# MILLPWR<sup>G2</sup> SOFTWARE UPDATE

January 10, 2019  
MILLPWR<sup>G2</sup> 2 & 3 Axis  
Release of Version R8SP1

**For Use with Consoles (ID#1113777-NN) ONLY**

Here are some side by side comparisons:

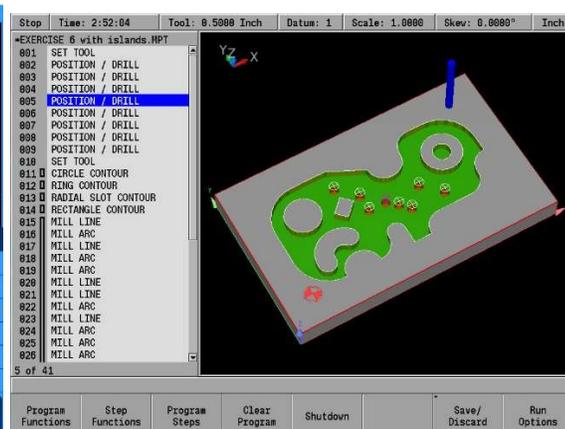
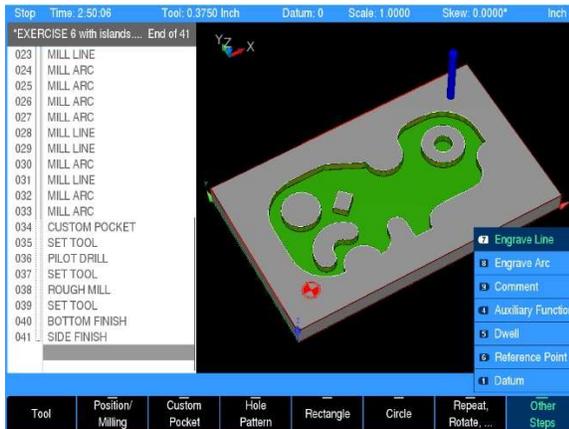
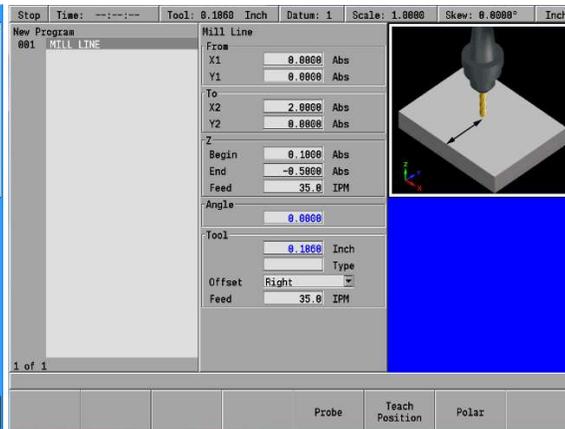
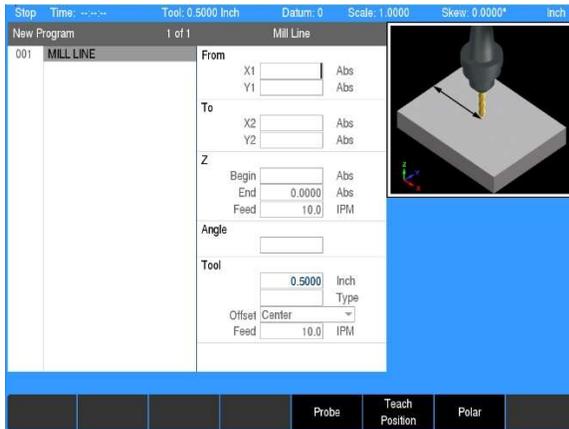
Note: Release 8 (R8) software includes many enhancements, prior to downloading this version be aware that the graphics of the user interface has changed. The user interface now uses a modern theme congruent with the latest versions of the newly released ACU-RITE digital readout products. Here are just a few of the changes, fonts, larger pop up menu's large qwerty keyboard, color highlighting of steps.
